AMENDED PLAN
Ref: A1

SHDC
Planning & Development
04 NOV 2005
Ref: 1456/03

PROPOSED GRD. FLOOR LAYOUT 1:100

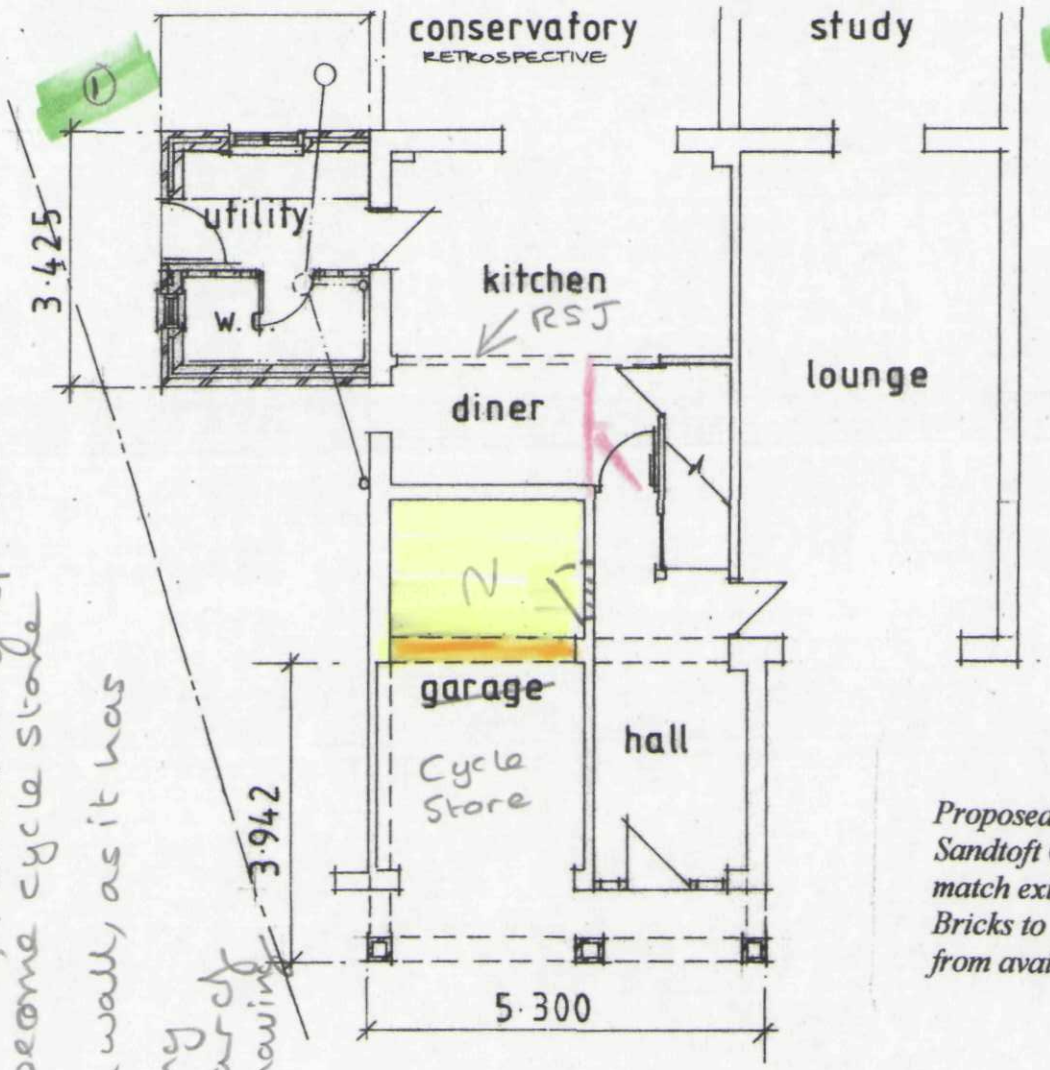
Change from brick built extension, as the area we are allowed to build on is so small, to a timber porch 3m wide x 1·8m deep. To include coat + shoe storage cupboard, exit door in same place opposite existing door.

Proposed Materials: Twin-wall roof *Sandtoft Calderdale Slate, to match existing.* so as not *Bricks to match existing, from available production.* to block light to kitchen

Create new w/c + shower room, create new door way in hall

Divide garage to create new room, remaining space to retain garage door and become cycle store

leave in one section of kitchen wall, as it has been deemed to be supporting

Only move kitchen door just clear of understairs cupboard, to avoid having to fill in part of banister area.
